Independent Pricing and Regulatory Tribunal
New South Wales

Assessment of revised Section 94 Contributions Plan No 21 – Marsden Park

Blacktown City Council

August 2017

Figure 3.1 Proposed transport Items in the MPP

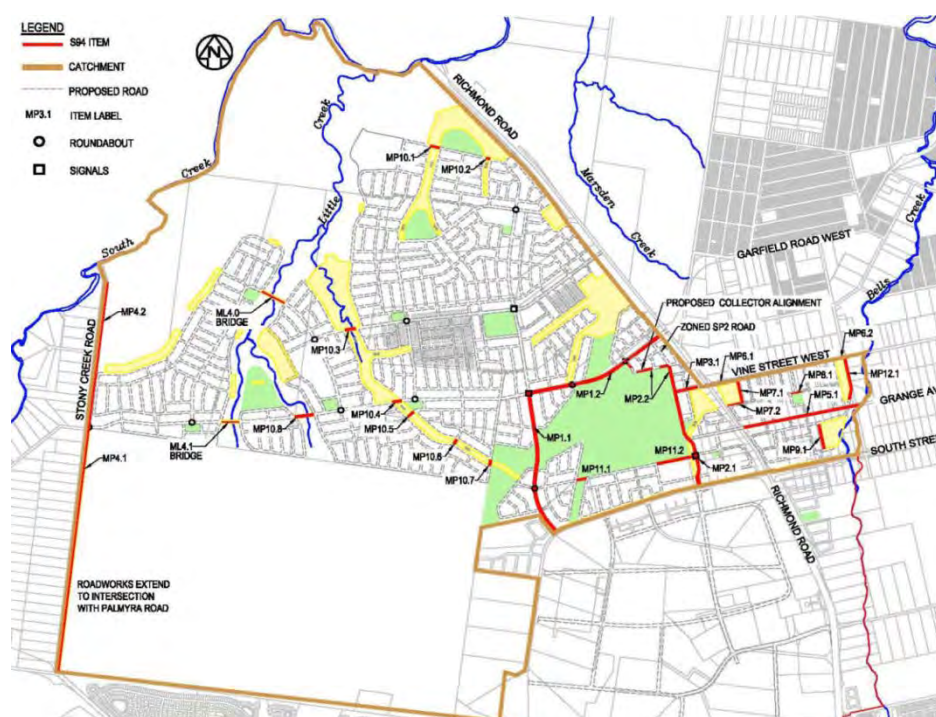
There are two bridges over Little Creek included in CP21 (ML4.0 and ML4.1 in Figure 3.1). These bridges cost \$12.5 million and \$12.1 million respectively, for a combined total of \$24.6 million.³⁵ The proposed bridges are 20.8m wide, and we assessed that narrower, lower cost bridges could still achieve satisfactory transport outcomes. We found that, assuming that safety concerns can be accommodated with a bridge width of 14m, reducing the widths to 14m would save an estimated \$8.0 million from the plan.

Stony Creek Road is a rural road located along the western border of the MPP (see MP4.1 and MP4.2 in Figure 3.1) and BCC proposes an upgrade to a collector road standard in CP21 to achieve “a satisfactory transport outcome” for the precinct.⁴⁸ We recommend excluding the road upgrade from CP21 on the basis that the road standard is sufficient to cater for the additional development in MPP, and the demand for an upgrade is generated from outside the precincts.

Grange Avenue is a rural road located to the east of Richmond Road (MP5.1 in Figure 3.1), for which BCC in CP21 proposes an upgrade to collector road standard. The cost of the upgrade is \$4.0 million..⁵⁶ Despite an upgrade not being recommended by the supporting study, we found that BCC has established reasonable nexus with the additional information it has provided as part of our assessment.

- 1 BCC consult further, at least with the NSW State Emergency Service (SES), to determine the minimum widths required for bridges ML4.0 and ML4.1 but in the interim, reduce the widths from 20.8m to 14.0m, thereby reducing the cost in CP21 by \$8,018,000.
- 2 BCC remove the cost of the proposed upgrade of Stony Creek Rd (\$6,945,000) from CP21.
- 3 BCC remove the cost of roundabout R1 (\$272,500) from CP21.

Figure 3.4 Collector road profile recommended by AECOM used in MPP

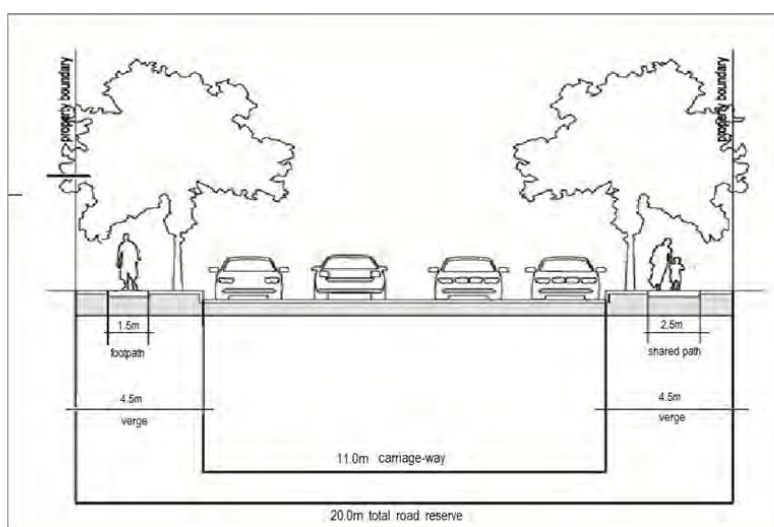
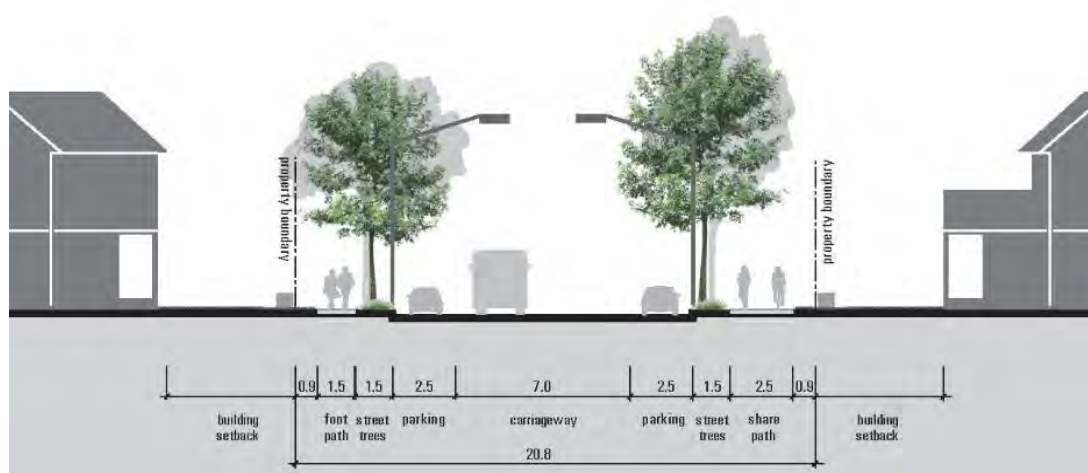
The width of 20.8m is based on AECOM's collector road cross section (Figure 3.4). BCC's Growth Centre's Development Control Plan (DCP) also provides for an 11m wide carriageway for collector roads within a 20m road reserve (Figure 3.3).³⁶ However, we do not consider a road profile is necessarily appropriate to guide a bridge's profile. As part of the consultation process, GLN Planning on behalf of Stockland noted it was difficult to understand how the width was warranted, as the full collector road profile does not have to continue for the length of the bridges.³⁷ GLN also noted that JWP, in its initial costings for its Flood Management Strategy Report,³⁸ assumed that both bridges would be 12m wide.

Figure 3.5 Map of roundabouts in the MPP

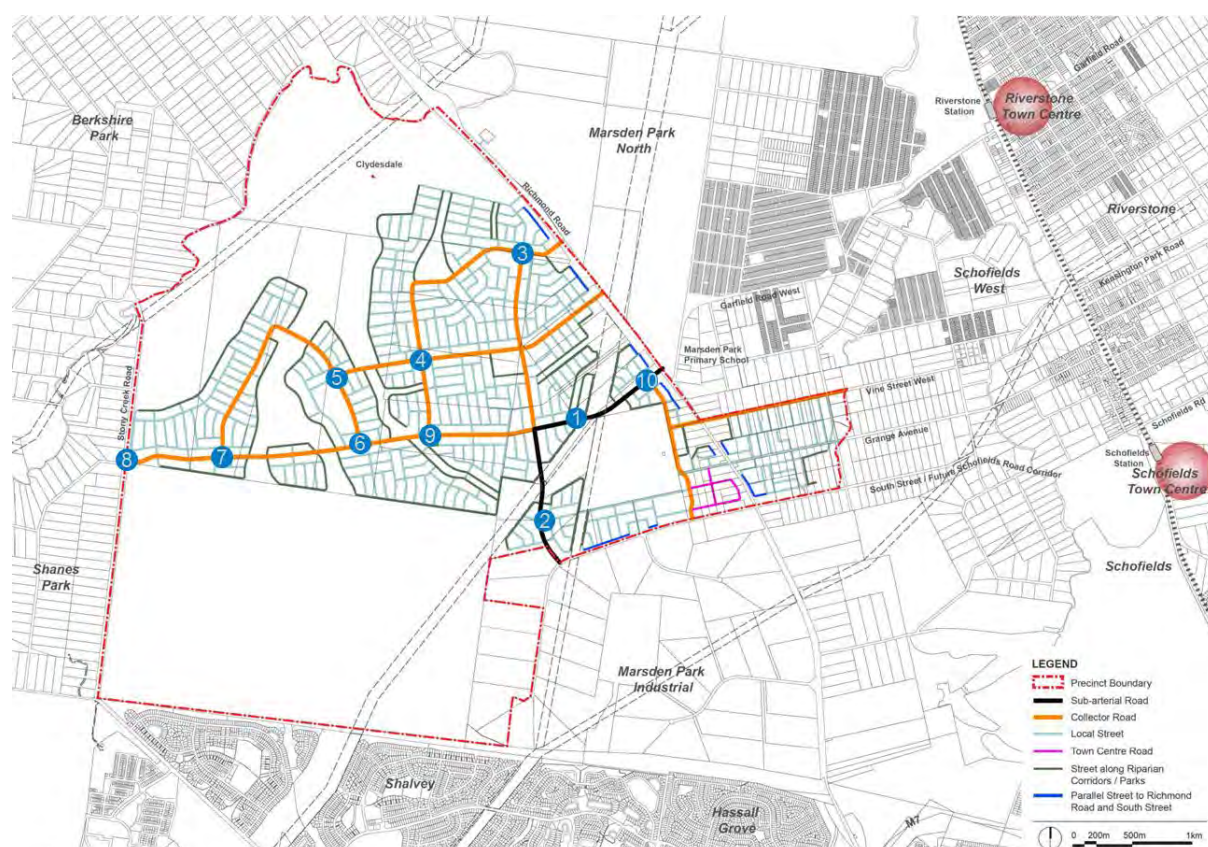
BCC proposes to build ten roundabouts in the MPP (Figure 3.5), costing a total of \$2.8 million. We consider nexus has been established for all but one of the roundabouts ('roundabout 1'). We recommend that the cost of this roundabout (\$272,500) is removed from the plan.

Figure 4.2 Constrained land for Channel L3.6 and M1.2

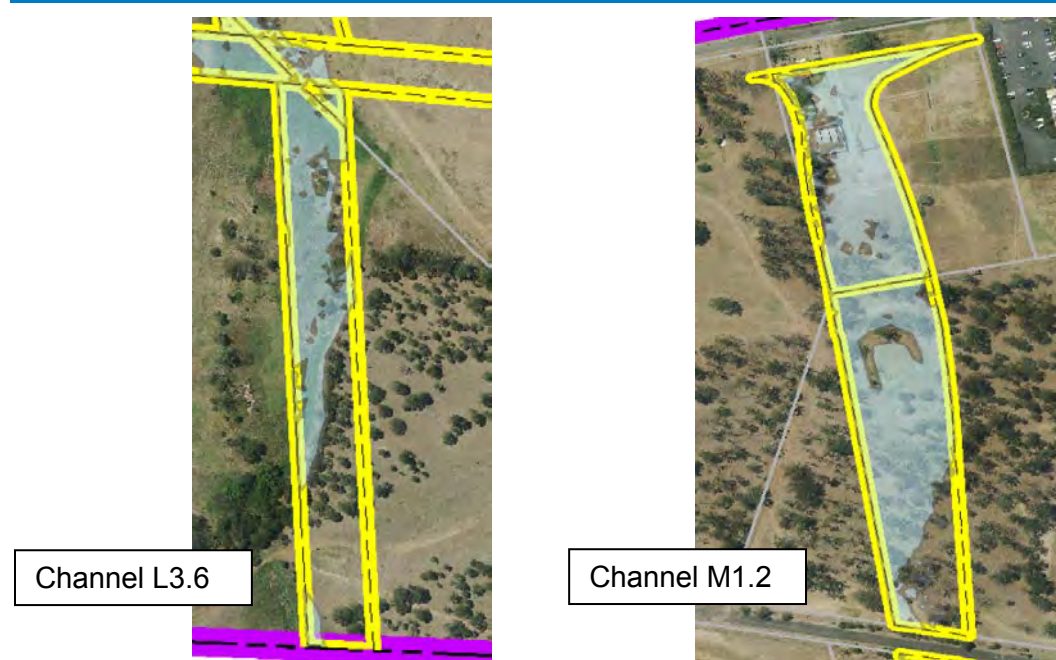
- 14 Consistent with Finding 5, the revised land acquisition cost for stormwater infrastructure is reasonable, except:
- the cost estimates for channels L3.6 and M1.2, which assumes that all land is unconstrained (with underlying zonings of IN2 and B7) when 50% and 80% of the land respectively is currently constrained.

This reflects our analysis of the proportions of land which are constrained and unconstrained in the costings, as summarised in Table 4.12 and displayed in Figure 4.2.

- 13 BCC reduce the proposed cost of acquiring land for stormwater purposes in CP21 by \$12,959,704 to \$230,252,045, reflecting BCC's revised cost estimates (a reduction of \$7,300,000) and an adjusted valuation for channels L3.6 and M1.2 to assume that 50% and 80% of the land is constrained (a reduction of \$1,333,080 and \$4,326,624 respectively).

Figure 1.1: Proposed roundabout intersections in the Marsden Park Precinct under investigation

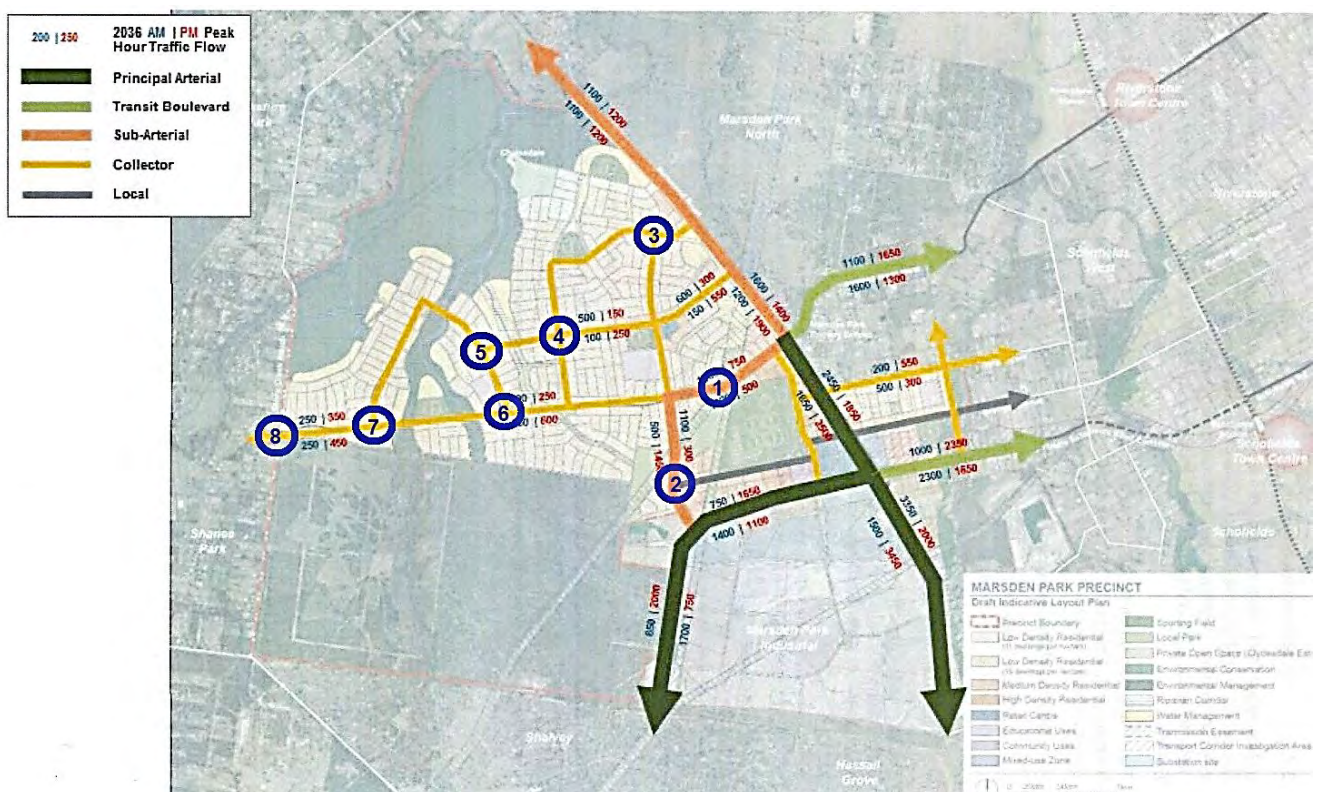
In accordance with the project terms of reference, the aim of the review is to determine whether eight proposed roundabouts are reasonable in terms of nexus. The location of the eight roundabout intersections is shown in Figure 1.1.

The proposed roundabouts, hence, involves ten intersections in the Precinct. Eight of which are within the scope of this review as identified in Figure 1.1. The roundabout at the Garfield Road extension/western north-south collector intersection, recommended in the technical document (AECOM 2013), is included in the miscellaneous transport item, but is out of scope for this review study. For other out-of-scope roundabout on the Garfield Road extension near Richmond Road, no detailed traffic analysis was provided in the AECOM study to support its implementation.
